The Detroit Edison Company
One Energy Plaza, Detroit, MI 48226-1279

May 10, 2010
NRC3-10-0020

Subject: Detroit Edison Company Response to NRC Requests for Additional
Information Related to Letter No. 27, SRP Section 13.06.01

Figure 1-1
Public Access Roads

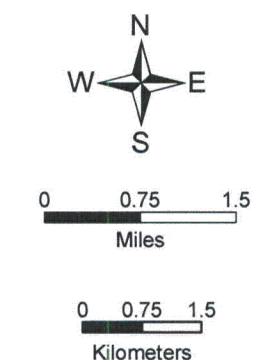
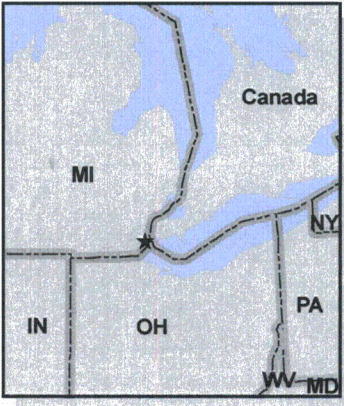
Section 1.1, Facility Physical Layout, Page 2: Figures 1-1, 1-1a, 1-2, 1-3, 1-3a, 1-3b, 1-3c, 1-3d, 1-3e, and E-1 are not of sufficient size/magnification or detail to clearly identify or discern the appropriate information such as OCA boundary, PA perimeter boundary, Vehicle Barrier System (to include natural terrain features), Vital Areas, major structures in these different security areas or the Independent Spent Fuel Storage Installation. The drawings should also clearly indicate the primary marshalling area for responding LLEA as indicated in the 2nd paragraph on page 2.

The figures included in the Fermi Physical Security Plan (PSP) have been enhanced and/or revised such that the required and requested information is more clearly depicted on the figures (with the exception of Vital Areas). Extraneous information has been removed from the figures, where appropriate, and the major site features pertinent to the PSP site description are better labeled. Figures 1-1, 1-1a, 1-2, and 1-3 are provided with this response. Figures 1-3a, 1-3b, 1-3c, 1-3d, and 1-3e are not included as the information presented in these figures is now clearly represented within Figure 1-3. Figure E-1 is not included as this drawing will be removed from the next revision of the PSP.
